Main Street (Route 6) – Road Safety Audit

July 20, 2016

AECOM

Figure 10. Utility Pole in Parking and Striped Buffer Area

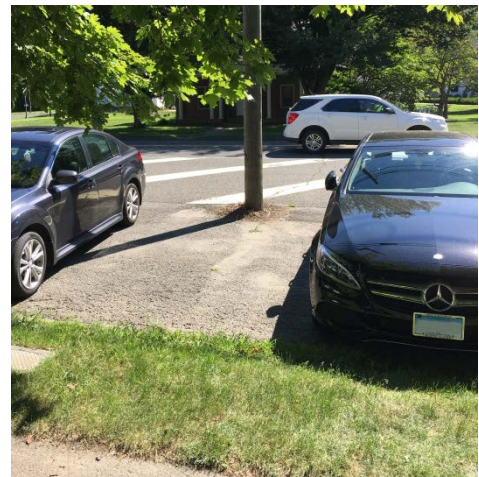
- There are approximately 15 parking spaces on the southbound side of Main Street near the Route 317 intersection. Part of this parking area is interrupted by the location of utility poles (Figure 10).

Figure 11. Corner Worn by Vehicles

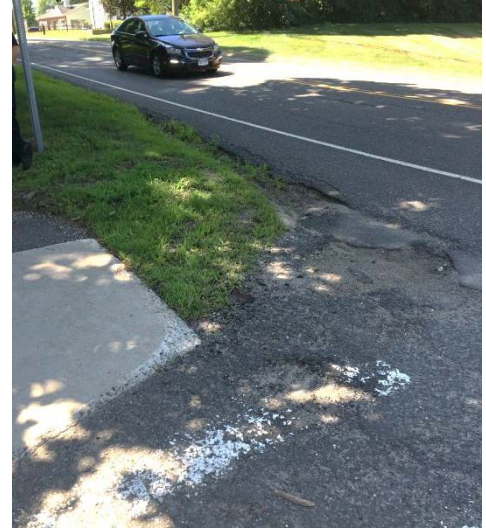
- At the Main Street and Old Sherman Hill Road intersection, the southeast corner shows signs of northbound vehicles traversing the grass strip and sidewalk (Figure 11).

Figure 19. Judson Avenue Intersection

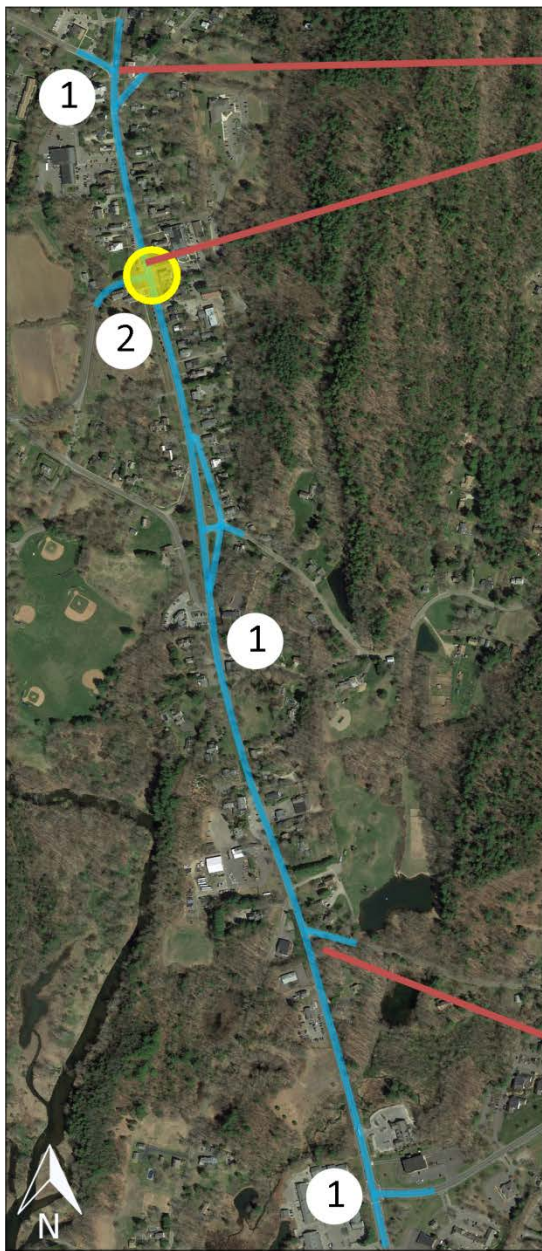
4. Reduce turning radius on Judson Avenue

Figure 25. Medium Term Recommendations

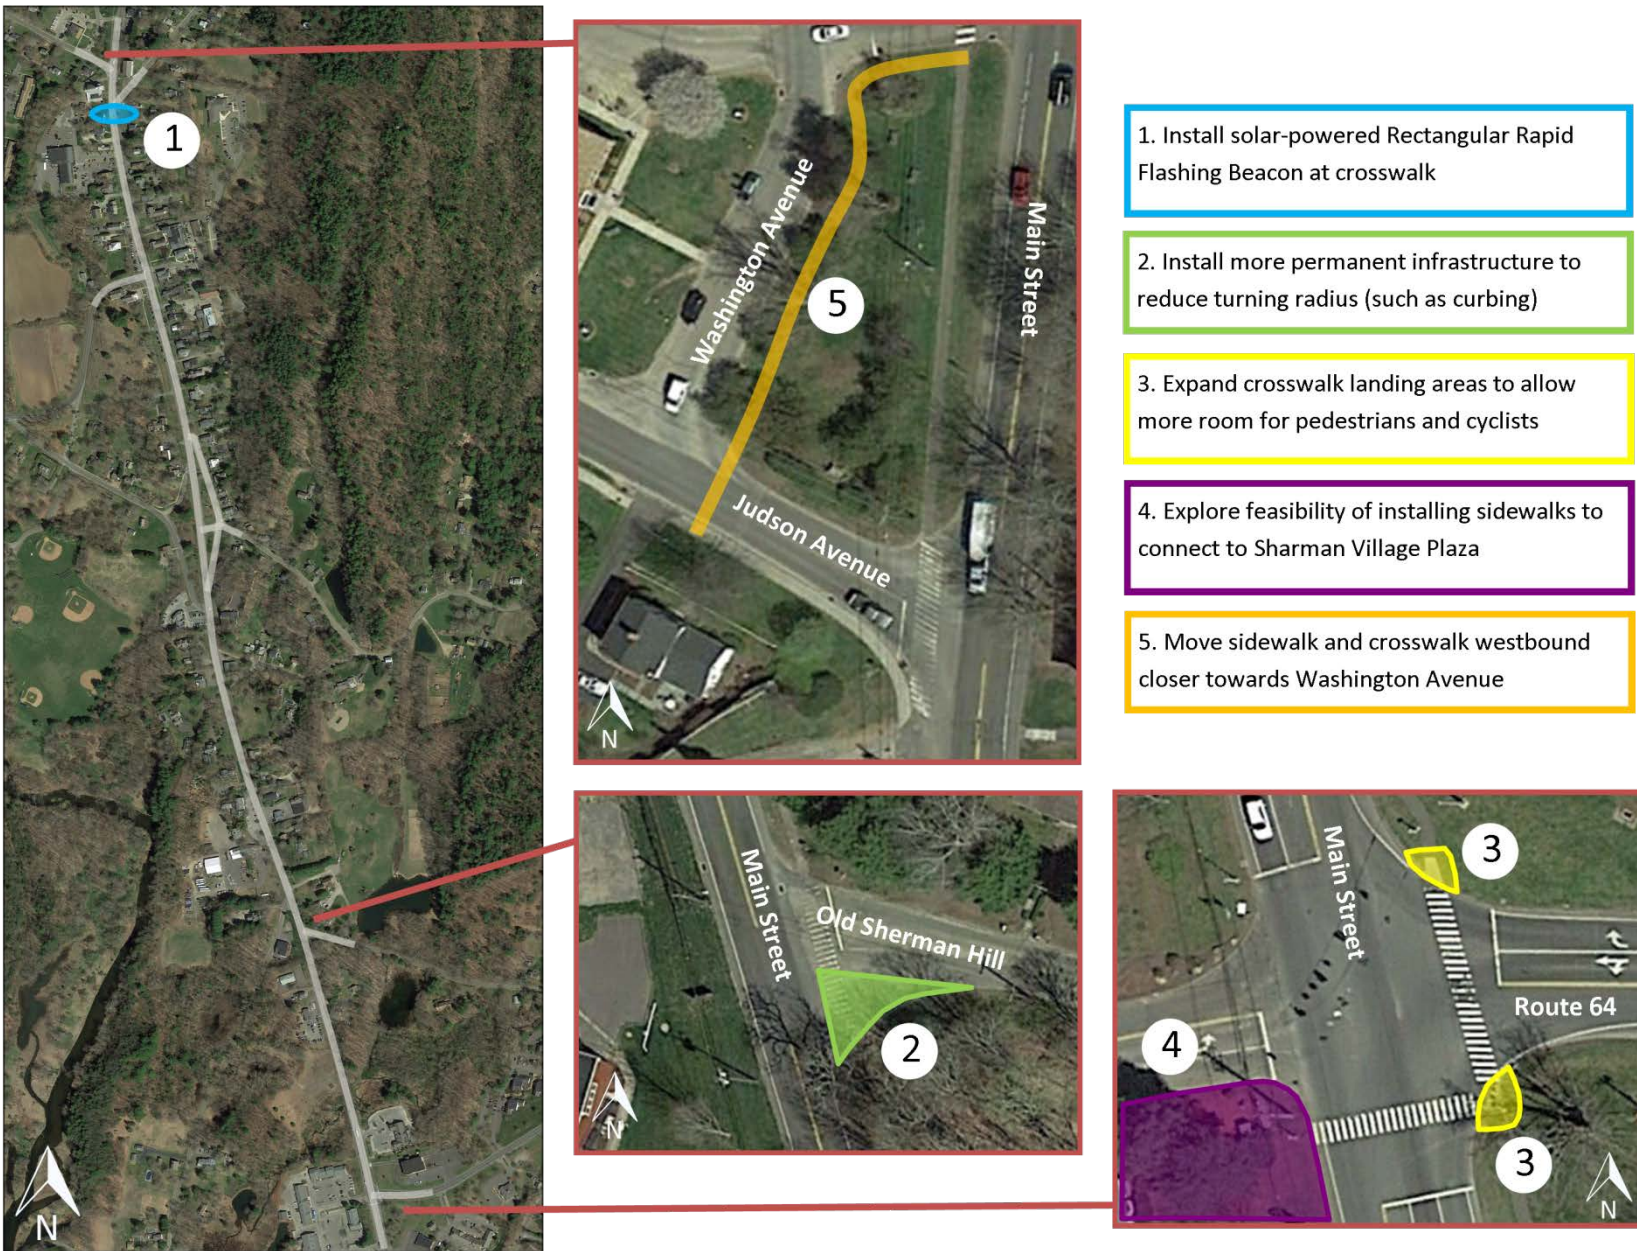
- 1) Consider installing a solar-powered Rectangular Rapid Flashing Beacon (Figure 21) at the Main Street crosswalk near Mountain Road.
- 2) If re-striping on Old Sherman Hill Road to make intersection more square was successful, consider installing more permanent infrastructure (curbing).
- 3) Expand the landing area at the crosswalks at the Main Street and Route 64 intersection (Figure 22).
- 4) Coordinate with business owners in plaza to explore the feasibility of building a sidewalk into the Sherman Village Plaza (Figure 23).
- 5) Move the crosswalk at the Main Street and Judson Avenue intersection closer towards Washington Avenue (Figure 24). Move the sidewalk to the western side of the island. This will keep pedestrians further away from traffic on Main Street and provide a crosswalk in area with better visibility.

1. Install solar-powered Rectangular Rapid Flashing Beacon at crosswalk

2. Install more permanent infrastructure to reduce turning radius (such as curbing)

3. Expand crosswalk landing areas to allow more room for pedestrians and cyclists

4. Explore feasibility of installing sidewalks to connect to Sharman Village Plaza

5. Move sidewalk and crosswalk westbound closer towards Washington Avenue

Figure 32. Long Term Recommendations

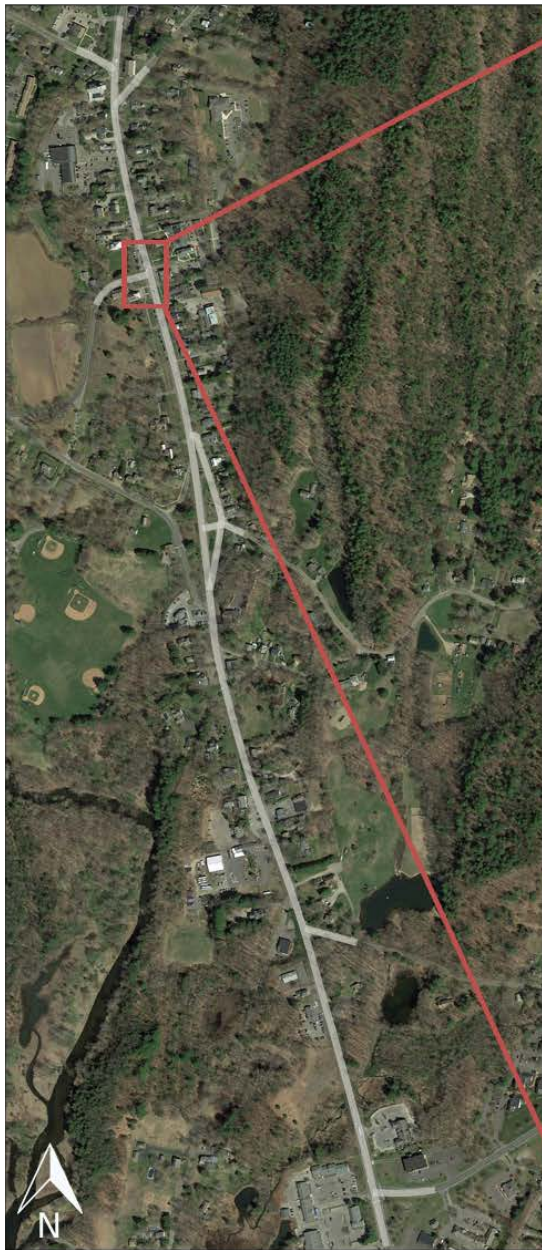
- 1) Eliminate perpendicular parking on Main Street at the Route 317 intersection and replace with parallel parking (Figure 26).
- 2) Remove the striped buffer area (Figure 27) and add a second traffic lane. Based on traffic count data, evaluate a new southbound lane configuration to best utilize the added lane capacity.
- 3) When the signal is upgraded at this intersection, coordinate with CTDOT and request the following:
 - a) ADA compliant signal heads (Figure 28) and crossing times.
 - b) ADA compliant ramps with tactile warning strips (Figure 29).
 - c) ADA compliant push buttons with audio signal (Figure 30).
 - d) Connect the gaps in sidewalks on both sides of Main Street (Figure 31).

1. Eliminate pull-in parking and replace with parallel parking spots

2. Remove striped buffer area and add a second southbound lane for right turns

3a. Install ADA compliant signal heads and update crossing times

3b. Install ADA compliant ramps and tactile warning strips

3c. Install ADA compliant push buttons with audio signals

3d. Complete gaps in sidewalks at all intersection corners
